# City of Portland Design Commission

## Design Advice Request

**Date:** November 6, 2018  
**To:** Portland Design Commission  
**From:** Puja Bhutani, Design Review  
 503.639.1575 | puja.bhutani@portlandoregon.gov  
**Re:** EA 18-261137 DA – Holden of Pearl, Senior Living  
 Design Advice Request Memo – December 13, 2018

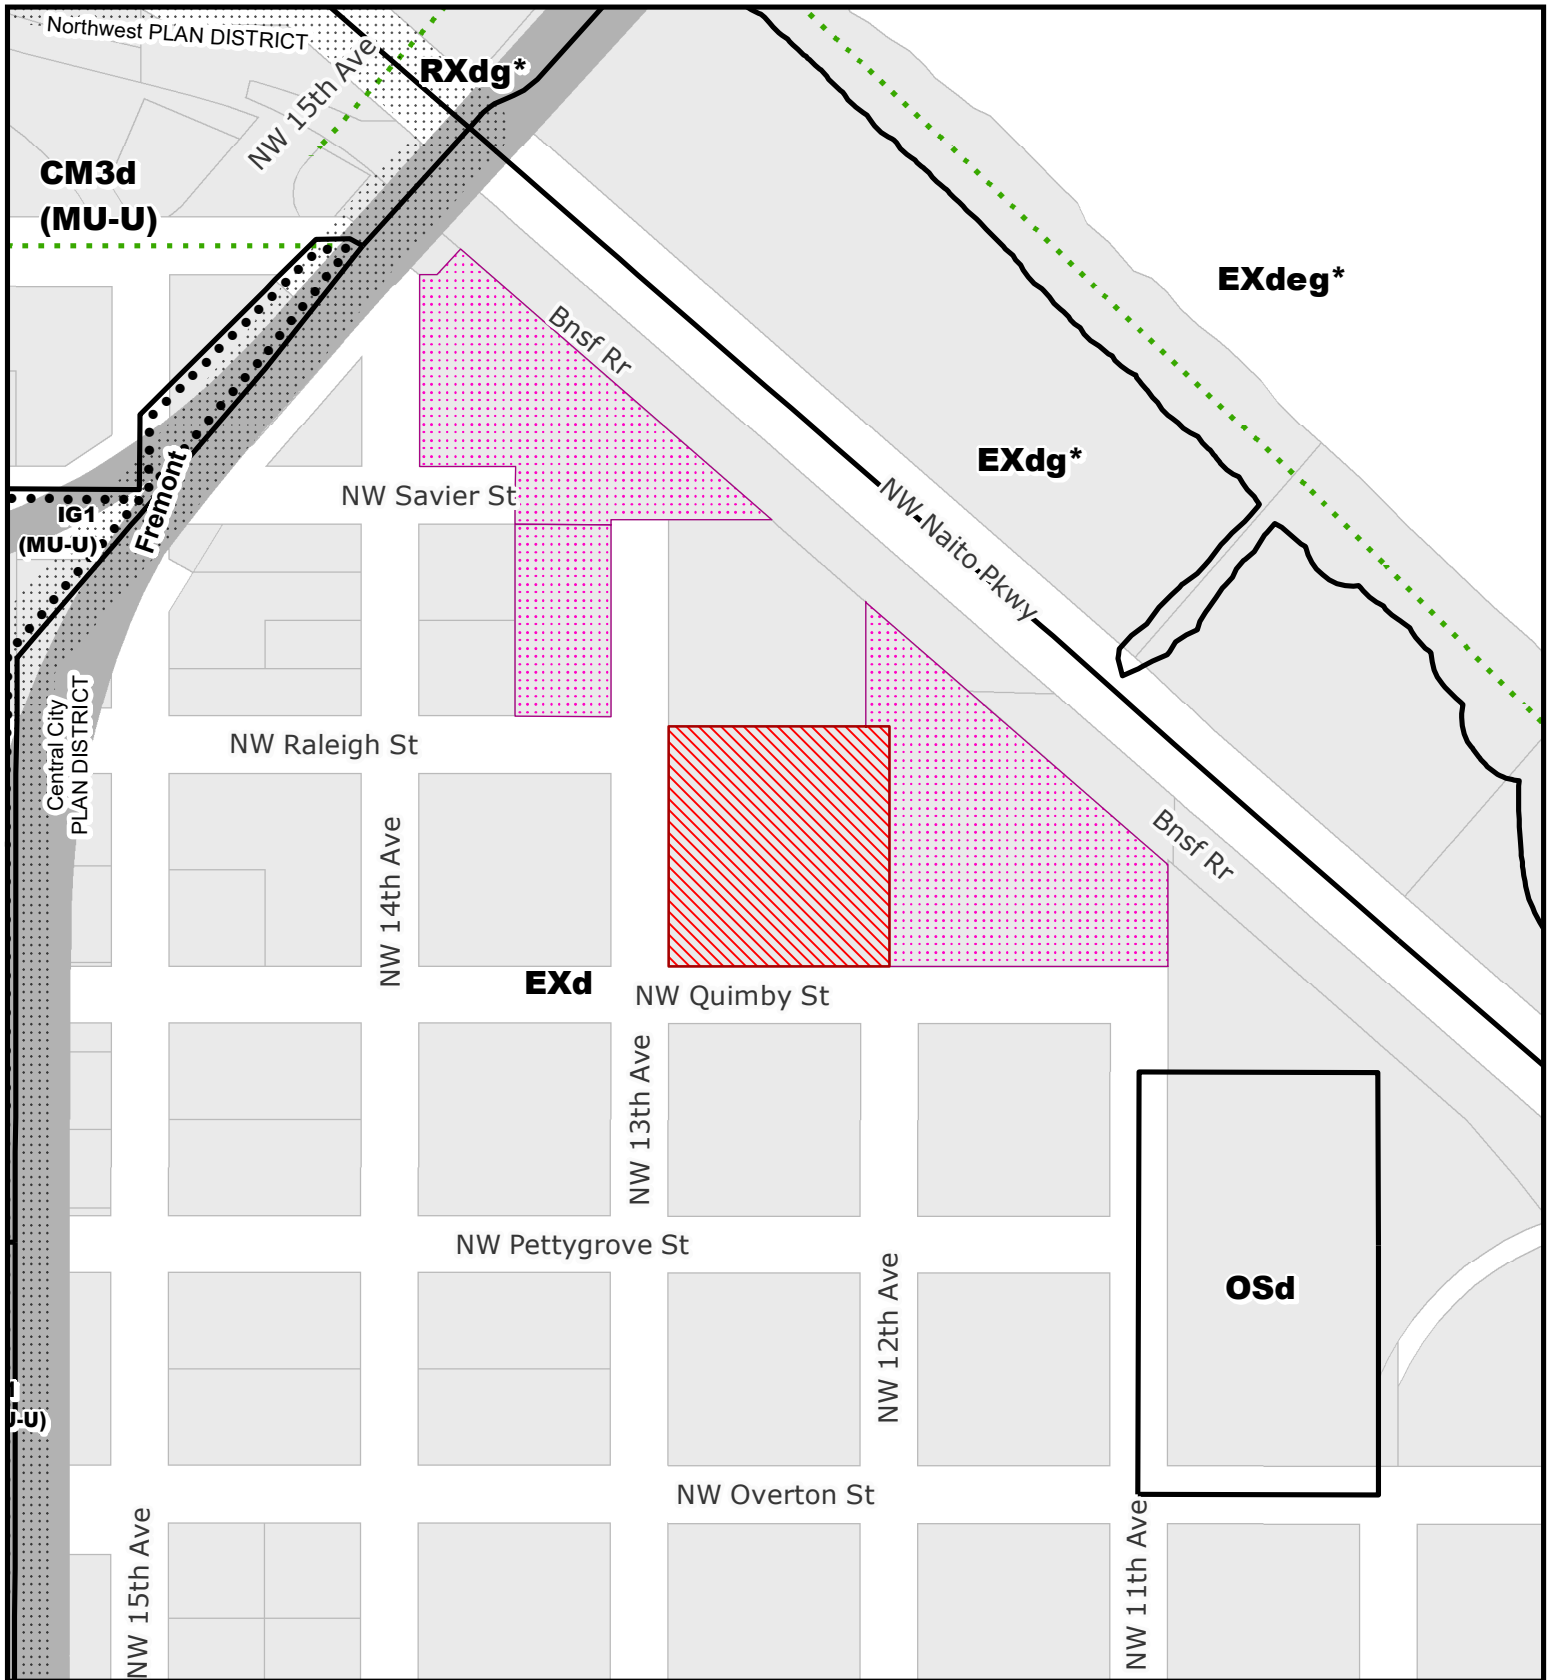
- ii. Building Setback:* The distance between the proposed and a future adjacent building on the east is critical to provide a pleasant and welcoming pedestrian/bikeway connection. At only 25' between buildings the pedestrian realm and inviting feeling of connection would be compromised. A successful pedestrian pathway usually requires a minimum of 40 feet width between the adjacent building facades. For instance, the

mid-rise buildings are separated by at least 40' for NW Kearney, which is a pedestrian street between NW 11<sup>th</sup> and NW 12<sup>th</sup>. The applicant should study and provide examples of successful resolution of pedestrian pathways and sections to support the proposed widths.
